APPLICATION NO.	FILING DATE	FIRST NAMED INVENTOR	ATTORNEY DOCKET NO.	CONFIRMATION NO.
10/727,306	12/03/2003	Douglas B. Wilson	114089.120 5202	
23483 WILMERHAL	7590 11/26/2007 .E/BOSTON		EXAMINER	
60 STATE STREET		LUONG, VINH		
BOSTON, MA	X 02109	,	ART UNIT	PAPER NUMBER
			3682	
			NOTIFICATION DATE	DELIVERY MODE
			11/26/2007	ELECTRONIC

*,	Application No.	Applicant(s)				
	10/727,306	WILSON, DOUGLAS B.				
Office Action Summary	Examiner	Art Unit				
	Vinh T. Luong	3682				
The MAILING DATE of this communication app	ears on the cover sheet with the c	orrespondence address				
Period for Reply						
A SHORTENED STATUTORY PERIOD FOR REPLY WHICHEVER IS LONGER, FROM THE MAILING DA - Extensions of time may be available under the provisions of 37 CFR 1.13 after SIX (6) MONTHS from the mailing date of this communication. - If NO period for reply is specified above, the maximum statutory period w - Failure to reply within the set or extended period for reply will, by statute, Any reply received by the Office later than three months after the mailing earned patent term adjustment. See 37 CFR 1.704(b).	ATE OF THIS COMMUNICATION 36(a). In no event, however, may a reply be tin fill apply and w

ATTACHMENT 1

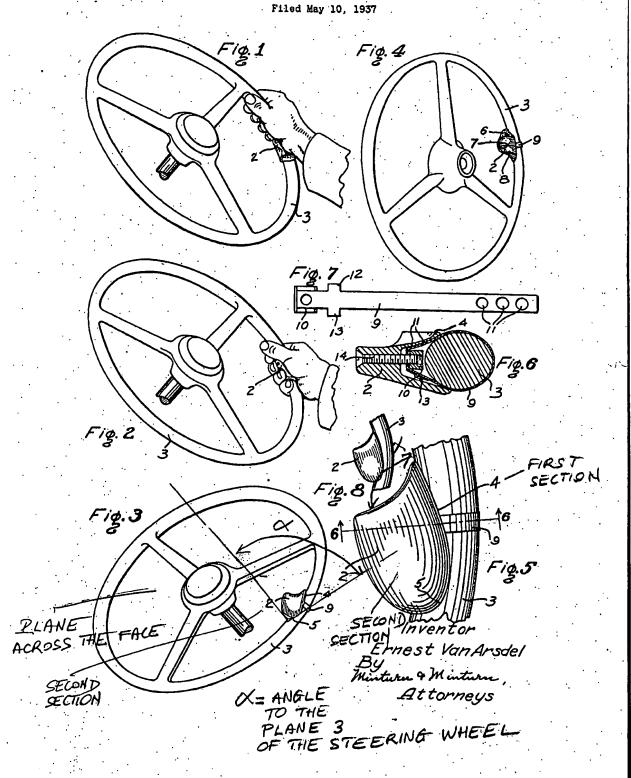
7. Claims 14-17, 19/17, 24/14, and 27/14, as best understood, are rejected under 35 U.S.C. 102(b) as being anticipated by Van Arsdel (US Patent No. 2,118,540).

Regarding claim 14, Van Arsdel teaches a fatigue relieving/preventing apparatus associated with a steering wheel 3 for controlling a vehicle, comprising:

a first section 4 (i.e., a horizontal section) that connects to a peripheral portion of the steering wheel 3; and

a rigid, semi-rigid or flexible, or non-deformable second section 2 that connects to, and extends from the first section 4 at the peripheral portion of the steering wheel 3, the second section 2 extends from the first section 4 outward at an angle (see angle α in Figs. 3 and 5 of Attachment 1) to a plane (Att. 1) across a front face of the steering wheel 3, the second section 2 for supporting at least a portion of a vehicular operator's body when pressure from the portion of the vehicular operator's body on the second section 2 is less than the pressure for deforming the second section 2 out of interference with the vehicular operator's ability to operate the steering wheel 3, and deforming out of interference with the vehicular operator's ability to operate the steering wheel 3 when pressure from the portion of the vehicular operator's body on

the second section 2 is equal to or greater than the pressure for deforming the second section 2 out of interference with the vehicular operator's ability to operate the steering wheel 3.

In the case at hand, on page 1, right column, lines 13-28, Arsdel describes: "[t]he grip rest 2 is *concave* longitudinally and about half of the rest extends over and part way across the steering wheel rim 3 in a manner to slope downwardly and inwardly of the rim. The outer edge 4 of the side, and 5 of the rear end of the *concave*, located above the rim, *extends up into a marginal flange* to be contacted by the inside of the ball of the thumb or by the bottom of the hand, depending upon which part of the hand is seated to rest." See also Arsdel's claims 1 and 2. Arsdel's concave upward section 2 extends from the first section 4 outward at an angle α to the plane across the face of the steering wheel as seen in Figs. 3 and 8 of Attachment 1 of the final action. Therefore, Arsdel's concave upward section 2 in Fig. 3 of Arsdel "reads on" Appellant's claimed second section.

Simply put, Arsdel explicitly teaches that the driver may loosen the screw 14 in Fig. 6 so that it is *deformable* in order that the driver can put extensive pressure on it and *it will move* for steering the automobile.

The support in the description of Arsdel for the statement that the second section will deform out of the interference with the operation of the steering wheel is found on page 2, left column, lines 28-32. By loosening or reversing the screw 14 sufficiently to permit Arsdel's second section 2 shifted vertically around the rim 3, the second section can be at the new position wherein the second section does not interfere with the operation of the steering wheel to suit the requirements or fancy of the driver.

ATTACHMENT 2

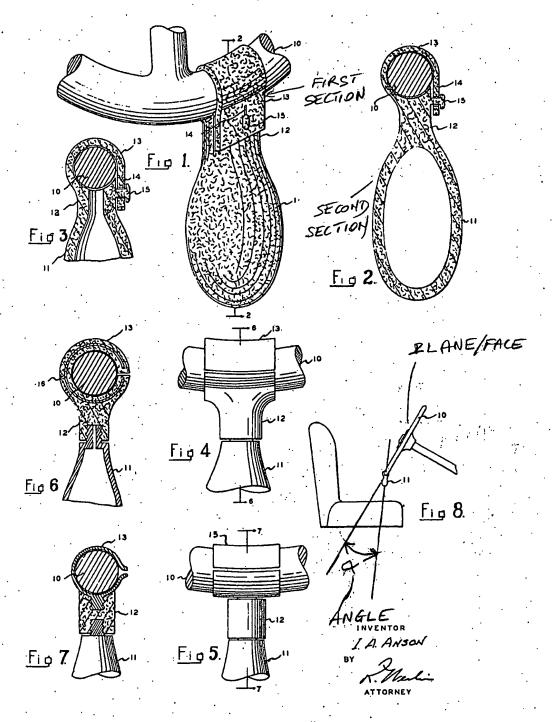
8. Claims 14-17, 19/17, 24/14, and 27/14, as best understood, are rejected under 35 U.S.C. 102(b) as being anticipated by Anson (US Patent No. 2,134,020).

Regarding claim 14, Anson teaches a fatigue relieving/preventing apparatus associated with a steering wheel 10 for controlling a vehicle, comprising:

a first section 13 that connects to a peripheral portion of the steering wheel 10; and a rigid, semi-rigid or flexible, or non-deformable second section 11 that connects to, and extends from the first section 13 at the peripheral portion of the steering wheel 10, the second section 11 extends from the first section 13 outward at an angle (see angle α in Fig. 8 of Attachment 2) to a plane (Att. 2) across a front face of the steering wheel 10, the second section 11 for supporting at least a portion of a vehicular operator's body when pressure from the portion of the vehicular operator's body on the second section 11 is less than the pressure for deforming the second section 11 out of interference with the vehicular operator's ability to operate the steering wheel 10, and deforming out of interference with the vehicular operator's ability to operate the steering wheel 10 when pressure from the portion of the vehicular operator's body on the second section 11 is equal to or greater than the pressure for deforming the second section 11 out of interference with the vehicular operator's ability to operate the steering wheel 10.

The instant assertion is likewise unsupported by substantial evidence in the record. In fact, Anson's grip is made of flexible or semi-rigid material, therefore, Anson's grip is deformable or deflectable out of interference with the vehicular operator's ability to operate the steering wheel, i.e., out of the normal position. See page 2, right column, and lines 25-40, quoted below:

As evidenced by the above quotations, Anson explicitly states that the driver may rotate Anson's attachment/handgrip about the wheel rim 10 to a position within the periphery of the wheel, *i.e.*, to a position shown in Appellant's Fig. 4 when the driver so desires. Anson's description reveals that Anson-type-attachment is operated in a similar manner to what is claimed in claim 14. As such, a person of ordinary skill in the art would find that there is a teaching in Anson in which the hand/other body part is supported by Anson attachment as

Further, since Anson's attachment may be rotated about the wheel rim from its normal pendent position to a position within the periphery of the wheel when it becomes desirable to dispense with its use in operating the wheel, Anson's attachment is capable to be rotated outward such that the second section 11 is at an angle from the plane across the face of the steering wheel and out of interference with the operation of the steering wheel as claimed.
